CUYAMA BASIN GROUNDWATER SUSTAINABILITY AGENCY STANDING ADVISORY COMMITTEE MEETING

AGENDA

April 25, 2024

Forest/Rangeland Management Basin-Wide Cumulative Storage Change (2019 Analysis)

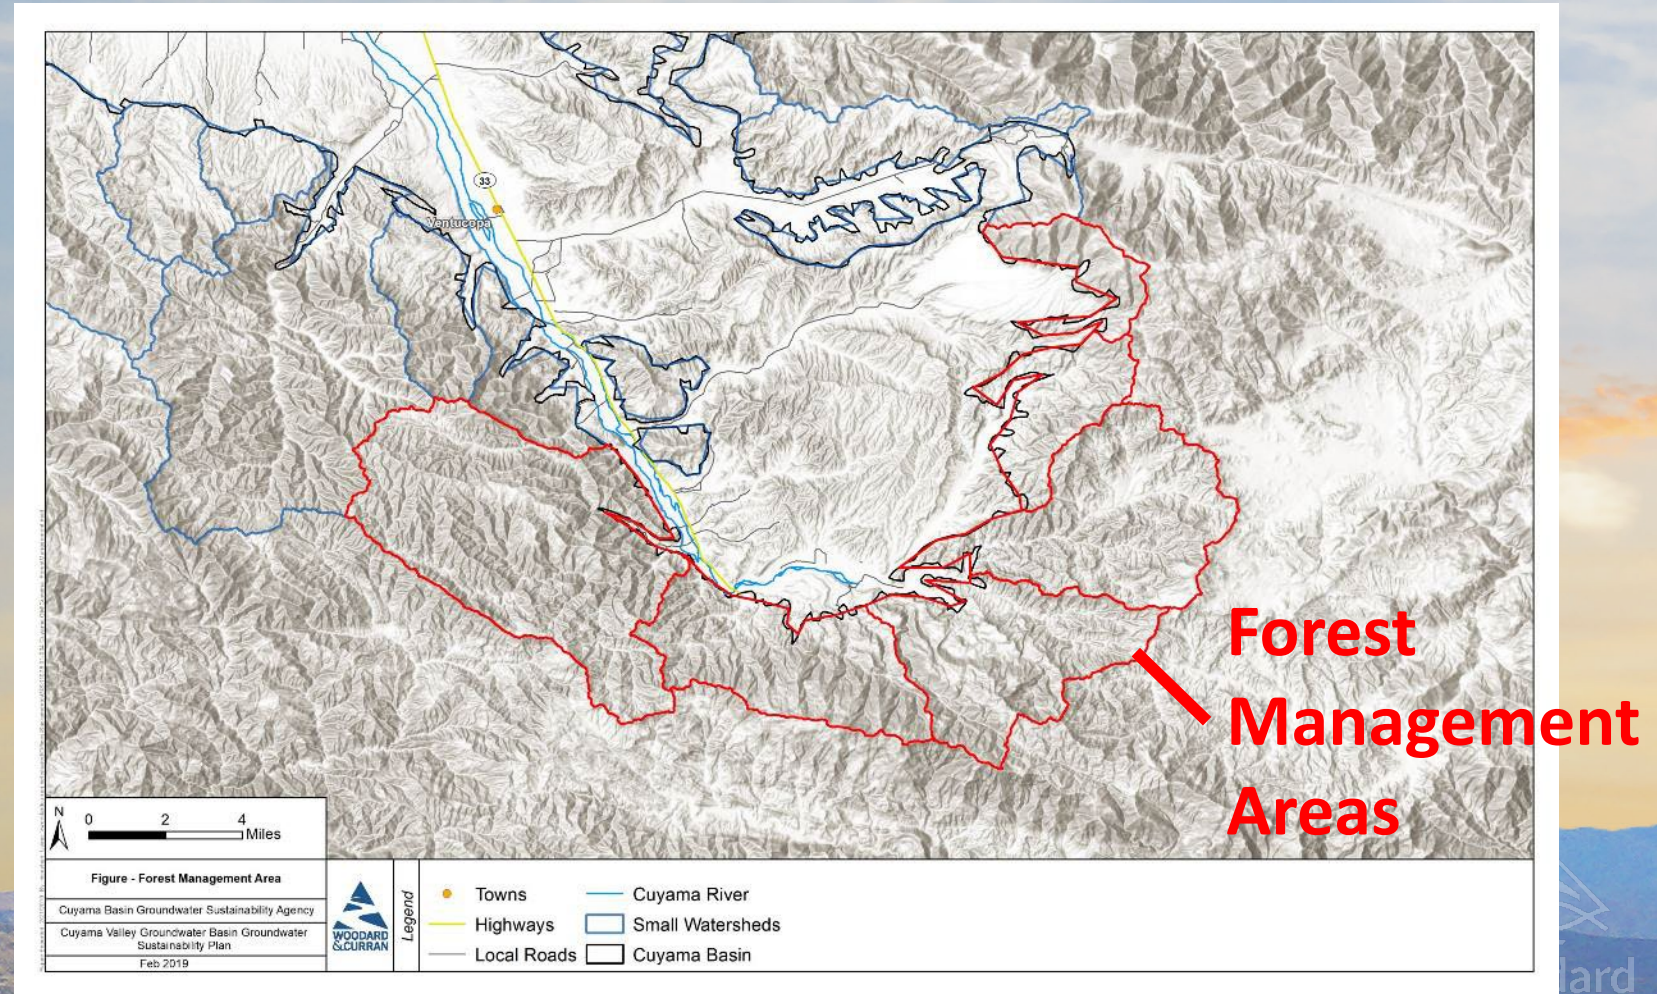
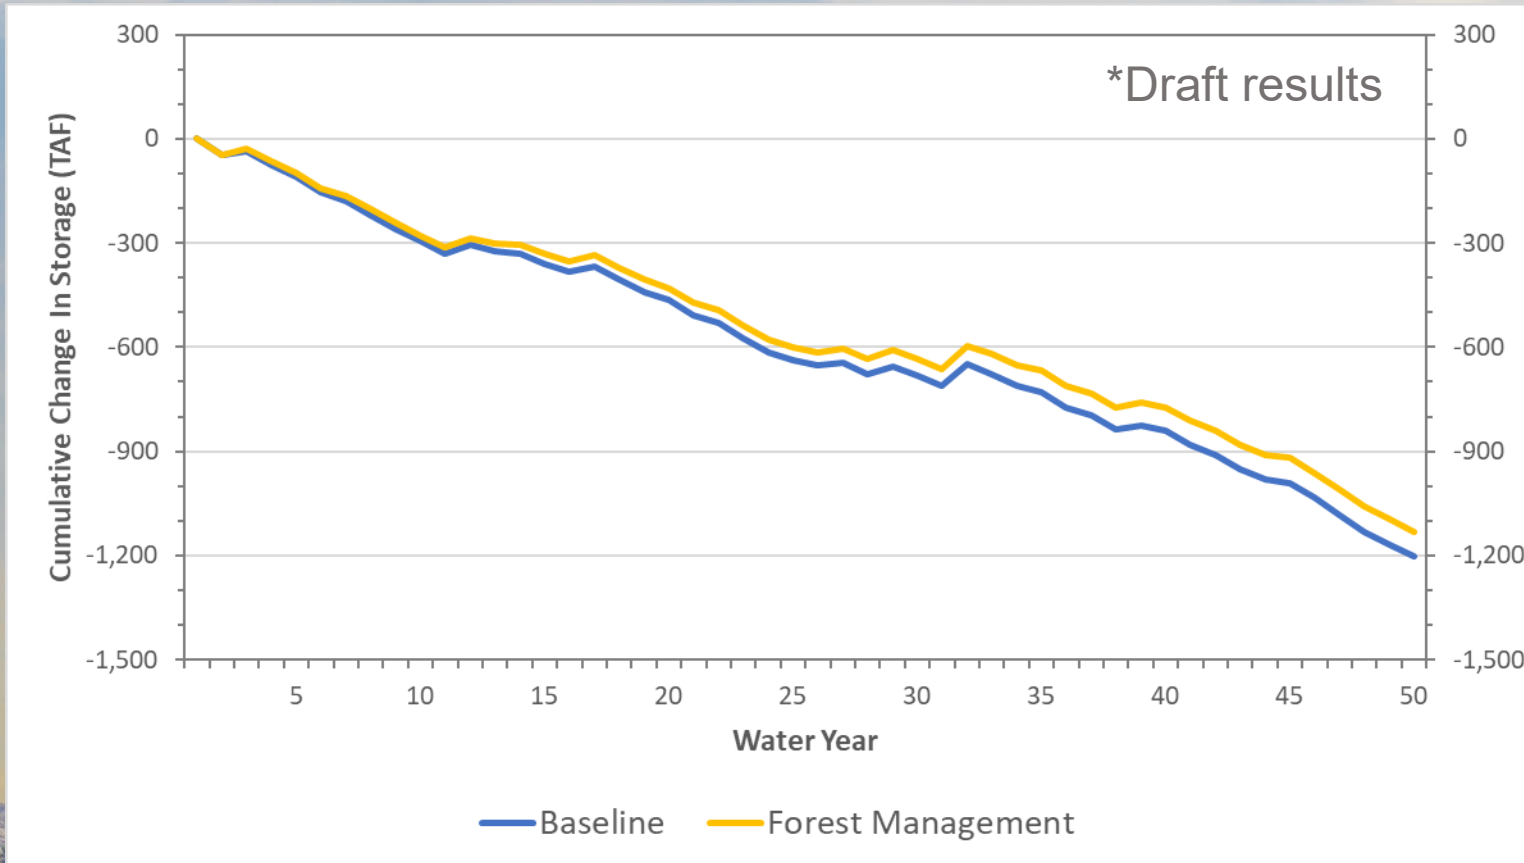
Comment by	Jeff Shaw, EKI (Cuyama Basin Water District)	Matt Young (Santa Barbara County Water Agency)
Comment	<ol style="list-style-type: none"> 1. <u>Flow meter</u>: Recommend keeping as a project for grant funding opportunities 2. <u>Rangeland</u>: Concerns with permitting feasibility 	<ol style="list-style-type: none"> 1. <u>Rangeland</u>: Concerns with permitting feasibility
Staff Notes	NA	NA
